**7000 Wisconsin Avenue  
Site Plan Submission  
Supplemental Narrative for November 20th Design Advisory Panel Meeting**

This Site Plan submittal is specifically focused on addressing all three of the DAP recommendations from the May 22nd meeting. Each of these recommendations is identified below with a summary of how the Applicant's Site Plan design addresses each comment as well as an analysis of the Proposed Development's compliance with the relevant Bethesda Downtown Plan Design Guidelines (the "Design Guidelines").

**7000 Wisconsin Ave  
Bethesda, MD**

**Design Advisory Panel  
Pre-Submission  
Preliminary Plan and  
Site Plan**

Massing in Context

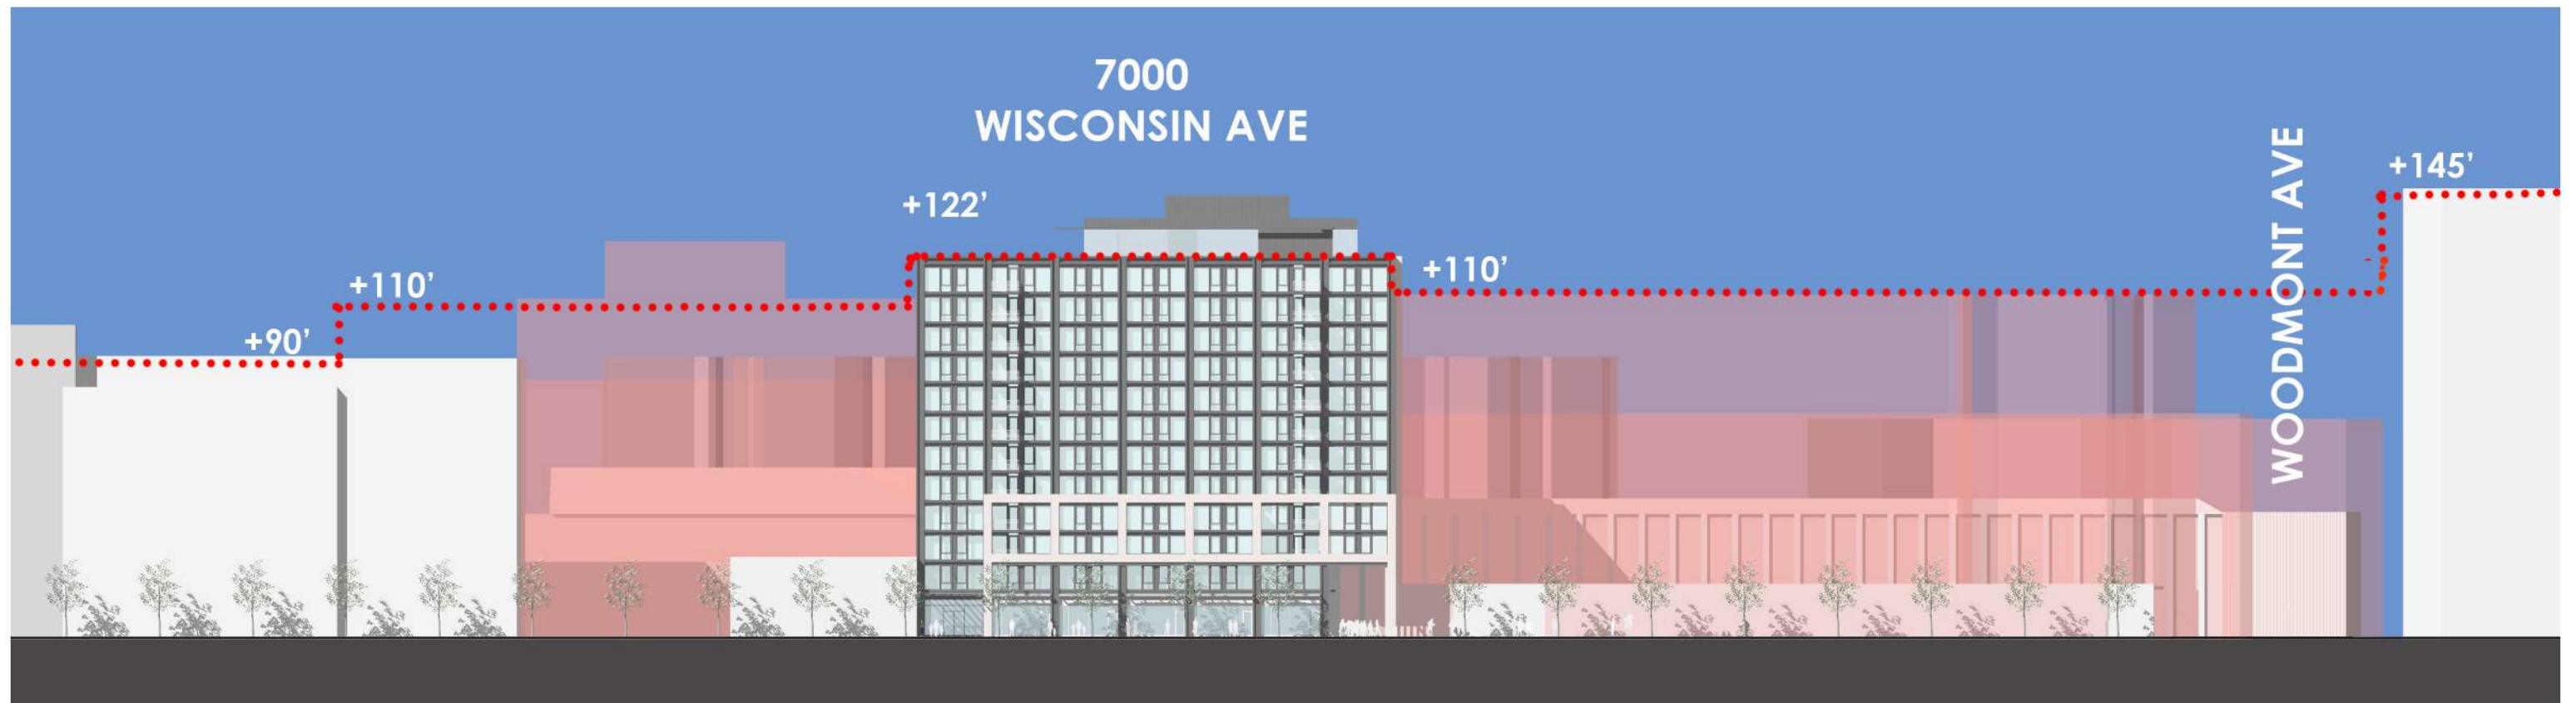
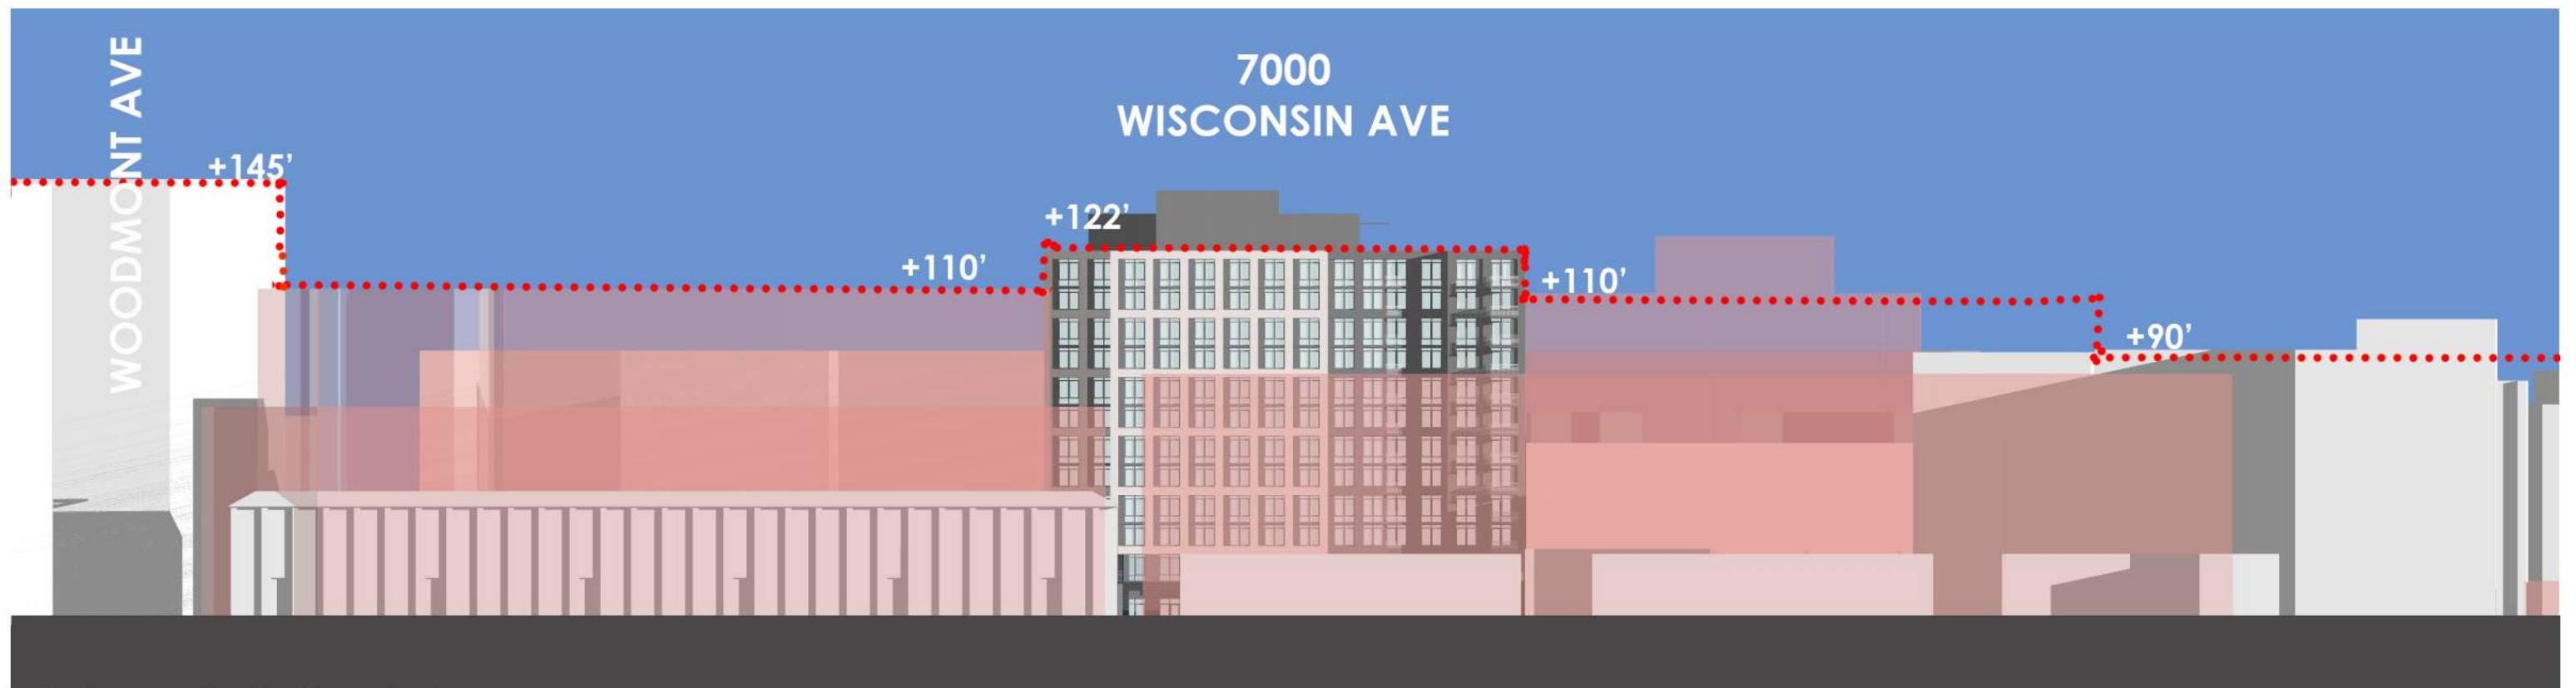
**DAP Recommendation 1.** Design a lower base height of approximately 35-45 feet to be in proportion to the height of the buildings and step-back the floors above no less than 5 feet, with 10 feet step-back recommended.

**Response:** Per the DAP's recommendation, the Applicant studied reducing the base of the building and increasing the tower step-back along Wisconsin Avenue at the upper floors. It was decided that for the viability of the project and visual integrity that a base of 45' and a setback of 6' is the appropriate direction for the following reasons:

1. The base height of 45' is approximately 1/3rd the height of the building, which is proportionally better than either a lower base or the maximum 70' allowed by the Design Guidelines.
2. The step-back of 6' is the proper dimension to setback the upper floors and provide a smooth transition from the lower floors, visually and in terms of constructability. If the base has a solid appearing façade it would in all likelihood be comprised of an exterior wall that is 1' thick. Within the residential floors in the base of the building, the inset

65 Foot Base Height -10 Foot Setback

45 Foot Base Height-6 Foot Setback
